TECHNICAL BULLETIN
Bell Helicopter **TEXTRON**

No. 212-01-186

MODEL AFFECTED: 212

SUBJECT: ENGINE POWER TURBINE GOVERNOR LEVER
RE-INDEXING, INTRODUCTION OF.

Figure 1

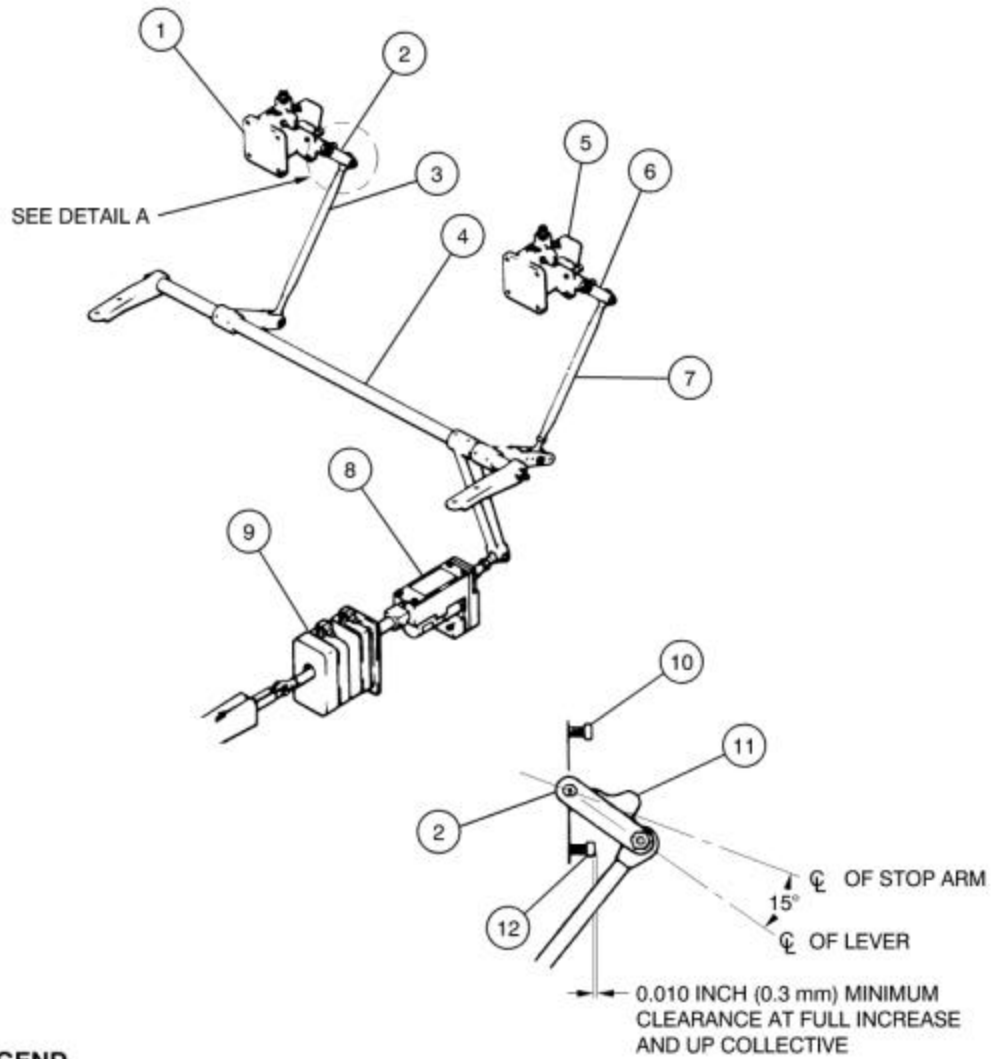
Bell Helicopter has become aware that when droop actuator P/N 204-060-762-103 is installed, there is a possibility of fouling between the aft firewall and the actuator. This condition can happen when collective is full "UP" and the actuator beep switch is full "INCREASE". The fouling condition is caused by the difference in body size between actuator P/N 204-060-762-005 and -103. The following technical bulletin introduces a change to the lever installation on the governor to eliminate the fouling condition.

1. Gain access power turbine governors (1 and 5, figure 1)
2. Disconnect control tube (3 and 7) from power turbine governors (1 and 5).

3. Re-index levers (2 and 6) on control shafts of power turbine governors (1 and 5). Centerline of lever (2 and 6) shall be approximately 15 degrees relative to the centerline of the governor stop arm (11) viewed from left (detail A, figure 1).
4. Install control tube (3 and 7) to power turbine governors.
5. Refer to the BHT-212- MM, chapter 76, Droop Compensator Controls for the rigging procedure for ground run and test flight.
6. Make an entry in the helicopter historical records indicating compliance with this Technical Bulletin.
